**CITY OF ISANTI
PLANNING COMMISSION MEETING
TUESDAY, January 19, 2021
Immediately Following the 7:00pm City Council Meeting
CITY HALL**

SUBJECT: Request by Homepride, Inc for consideration of a Preliminary Subdivision and a Planned Unit Development called "Fairway Greens North" at PID's 16.020.1000 and 16.020.0803

Date: January 13, 2021
To: Sheila Sellman, Community Development Director
From: Jason W Cook, P.E.
City Engineer
Subject: Fairway Greens North - Preliminary Plat Review
City of Isanti, MN
Project No.: 0R1.123130

FAIRWAY GREENS NORTH PLAN REVIEW

Preliminary Plat of FAIRWAY GREENS NORTH

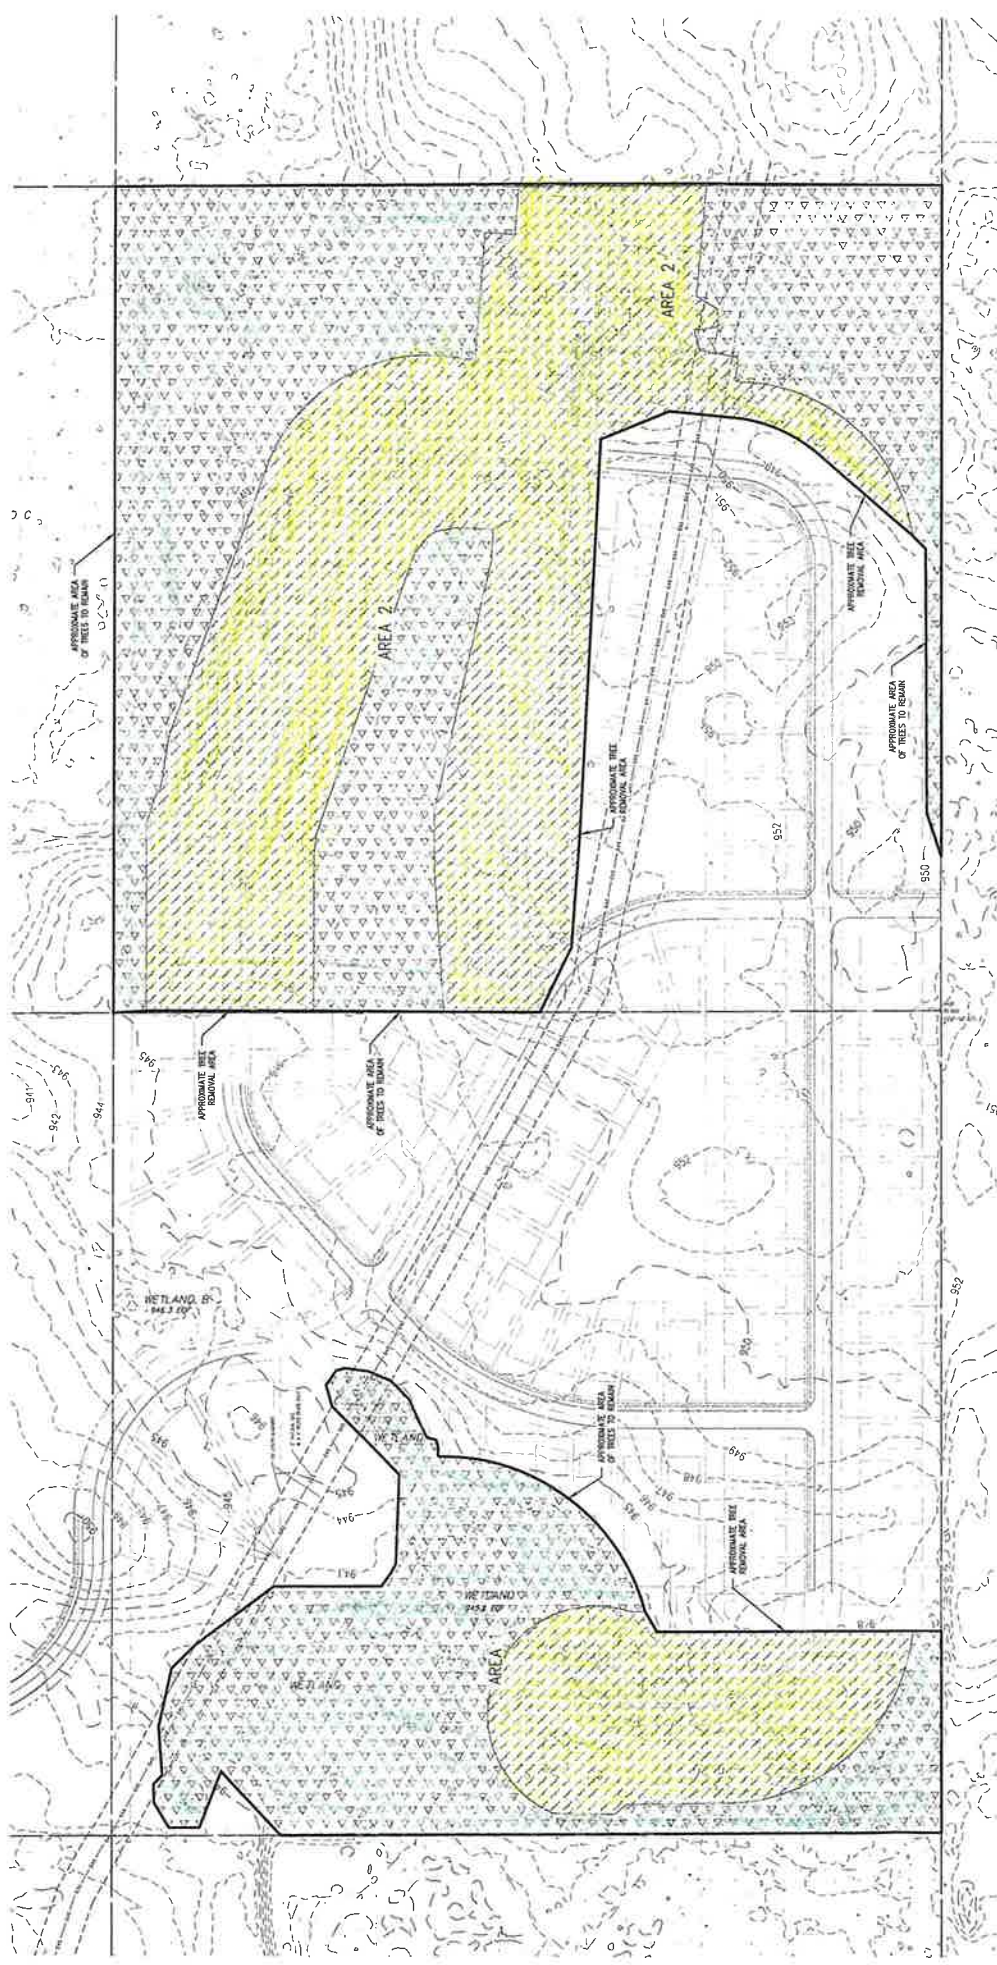
As proposed the average lot size is 16, 439 square feet. Density for this development is about 2 units/acre which is line with the low-density land use designation. It is not clear if the lots along the golf course will have reduced setbacks as on the plat they appear to be less. If these are patio homes it is typical to see a 5-10' setback around the entire dwelling.

A 3.61-acre lot is shown on the preliminary plat as park space. This will be open space and will not be improved with equipment. The City Council will need to determine if they want to accept this park and provide a park dedication per city code. If the city does accept this space it should be platted as an outlot.

The main access to the development is from 7th Ave NE with one way in and one way out. The fire code requires that single family development with more than 30 units shall provide two separate and approved fire apparatus access roads. In addition, dead-end fire apparatus access roads in excess of 150 feet in length shall provide an approved area for turn arounds. A second access should be added, a suggestion is to create an additional access off 8th street and connect to the proposed cul-de-sac. This could be part of the phasing plan; the second access should be added once 80 lots are platted. The proposed streets are public and are subject to city code requirements.

1. Show wider drainage & utility easements where pond grading, swales, and storm pipes extend outside currently shown easements.
2. Add access easement to ponds for future maintenance.
3. Add secondary road access branching off 8th Avenue NE connecting to proposed cul-de-sac. Make curve as large as possible coming off 8th Avenue.
 - a. It appears additional lots could be added along the south side of the development if the road is connected turning Block 6 Lot 16 into 5 lots.
 - b. This secondary access will be required once 80 lots are platted.
4. What is the intent with the square 2-acre box on the west side of the plat? This does not appear to be used for storm water per the plan. Will this be an outlot? Should it be removed from the plat?

5. Existing subcatchment areas are not defined by property lines. Include off site runoff draining onto the site. This cannot be blocked off and must be included in the modeling.
6. Model the existing wetland for 100-year high water elevation and show the proposed culverts will not restrict this flow and affect bounce elevation or drain the existing wetlands.
7. Verify ground water will be over 3-feet below the bottom of all proposed infiltration basins. Provide geotechnical report showing this and have percolation tests completed to determine infiltration rate. Revise model as needed.
8. Provide existing and proposed discharge rates at each discharge point on the site, not as one total runoff rate.

9. The West Pond needs to treat its individual required Water Quality Volume. It appears there is significantly more room in the outlot than is being used for this pond. It also appears a proposed swale is not within the proposed easements and outlot area.
10. Subcatchments for each CB needs to be determined and spread calculations submitted.
11. CB-02 will require a saffle baffle type structure at a minimum. All other locations that discharge directly to wetland also require treatment structure, and equivalent treatment area oversized in other ponds.
12. Submit pipe sizing calculations for all storm pipes.

15. Submit a proposed Phasing Plan.
16. Show proposed building Low opening is 2 feet above the 100-year event and 1 foot above the emergency overflow in each sub catchment area.

17. Vertical curve lengths shall be 90' minimum (30 mph minimum design).
18. Sewer & water services shall be placed approx. 5-10 feet from property corners, not center of lots.

19. Show emergency overflow locations and stabilization for all pond EOFs.
20. Revised swale and location of CBMH-64 to fit within easements or outlots.

21. Label existing contours.
22. Verify all grading over existing gas main will maintain required cover. For example, there appears to be a 5-foot cut over the gas line in block 4.

23. All storm pipe withing ROW shall be RCP.
24. Low points shown at the back of multiple building pads. Back yards need to have positive drainage away from building pads and no trapped water. (ex Block 6 Lot 41 and Block 3Lot 18.)

25. Sanitary sewer main should not be under 6 feet deep. Any sewer 6-feet to 8-feet deep should be insulated. Verify all 4-inch services can be installed at 1% minimum grade and still service all proposed building elevations.

26. Watermain shall be 7.5-feet deep at a minimum and will need to be extra depth where sanitary services are shallow.

27. Watermain will need to be looped to 8th Avenue along with the road looping discussed in the above preliminary plat section.
28. Are the road widths labeled at Face to Face or Back to Back?
29. Submit horizontal curve tables showing design speed.
30. Show all sidewalk at a minimum of 1' from ROW edge. Some intersections appear to need chamfered corners at pedramps.
31. The pavement section shall be determined by the geotechnical report, but at a minimum:
 - a. 1.5-inches of bituminous wear course
 - b. 2-inches of bituminous non-wear course
 - c. 8-inches of aggregate base class 5
32. Show street lighting plan.

- 1) Fire apparatus access is currently limited to one street.
 - a. **D107.1 One- or two-family dwelling residential developments.**
Developments of one- or two-family dwellings where the number of dwelling units exceeds 30 shall be provided with two separate and approved fire apparatus access roads, and shall meet the requirements of Section D104.3.
 - b. **D104.3 Remoteness.**
Where two fire apparatus access roads are required, they shall be placed a distance apart equal to not less than one half of the length of the maximum overall diagonal dimension of the lot or area to be served, measured in a straight line between accesses.
- 2) Dead end roads do not have ample cul-de-sac.
 - a. **503.2.5 Dead ends.**
Dead-end fire apparatus access roads in excess of 150 feet (45 720 mm) in length shall be provided with an *approved* area for turning around fire apparatus.

2. All comments and conditions of the Fire Chiefs memo dated January 14, 2021 should be met.
3. Minimum lot size shall be 9,600 square feet.
4. Setbacks for the principal structure shall be as follows: Front 30' Side 8' Rear 20'

5. Clarification on the lots along the golf course and what those setbacks will be.
6. A phasing plan shall be submitted.
7. Final Plat be submitted and approved

ISANTI CENTENNIAL COMPLEX 7TH REARRANGEMENT

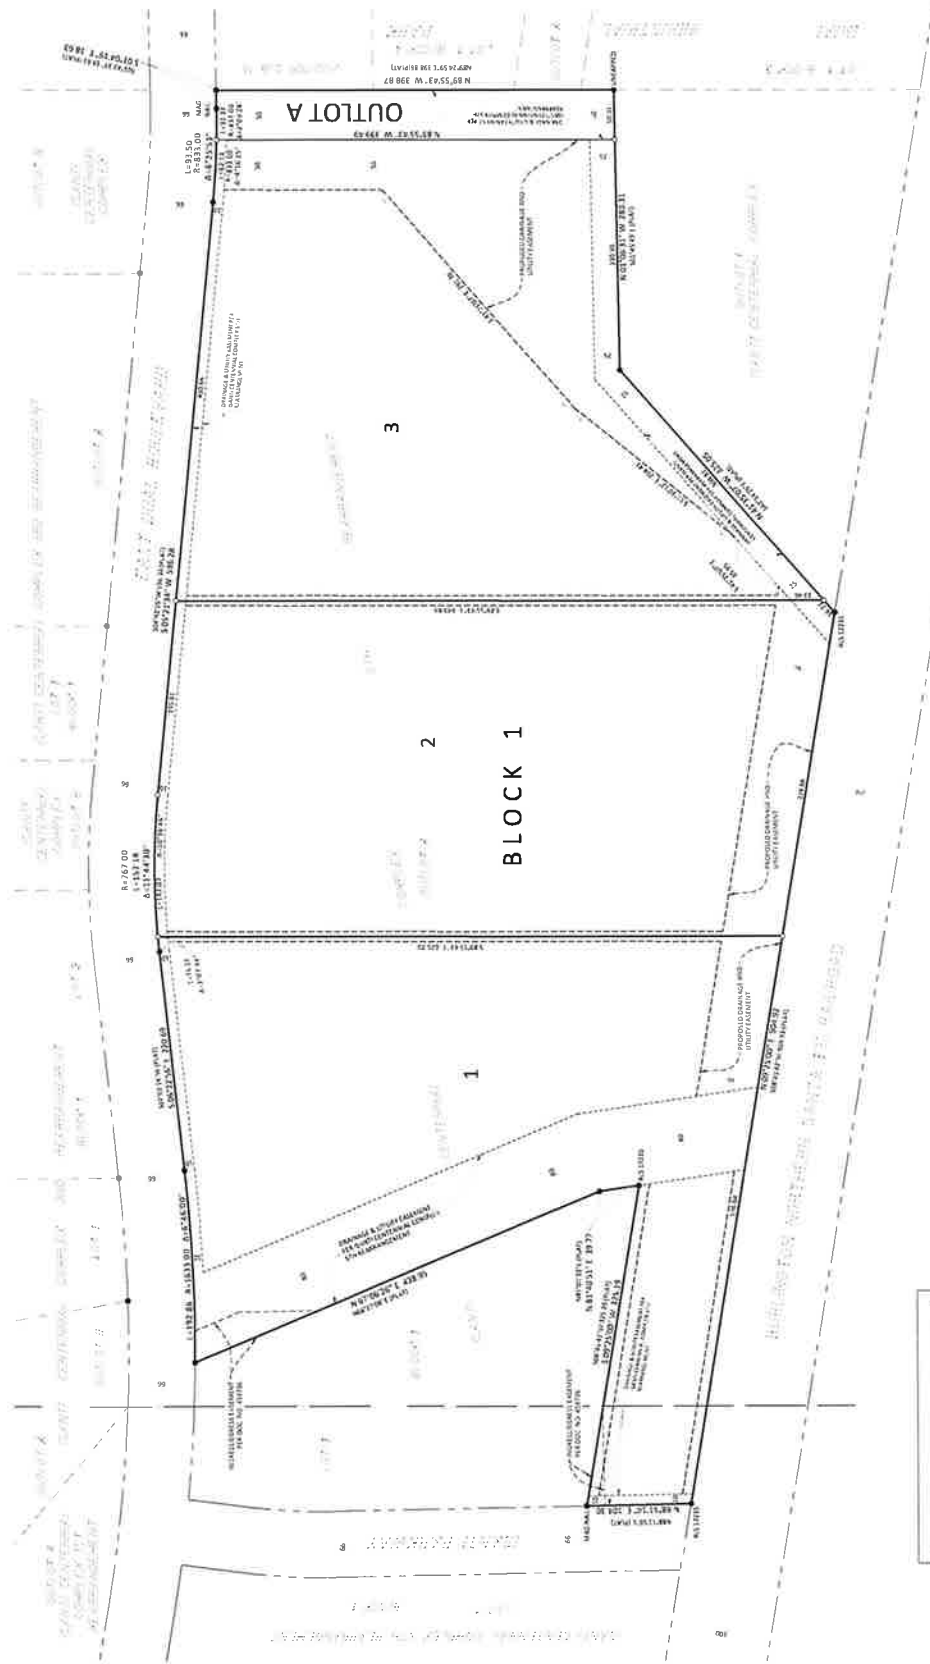
The 15.49 acre site has multiple City ditches and an access to the City water tower site on it. Some of these ditches were not in drainage and utility easements so new easements were written to cover the existing ditch system. The driveway to the water tower did not have a properly documented access so an Outlot was created to cover the water tower driveway and the utilities that are in it.

We recommend approval of the preliminary and final plats as submitted.
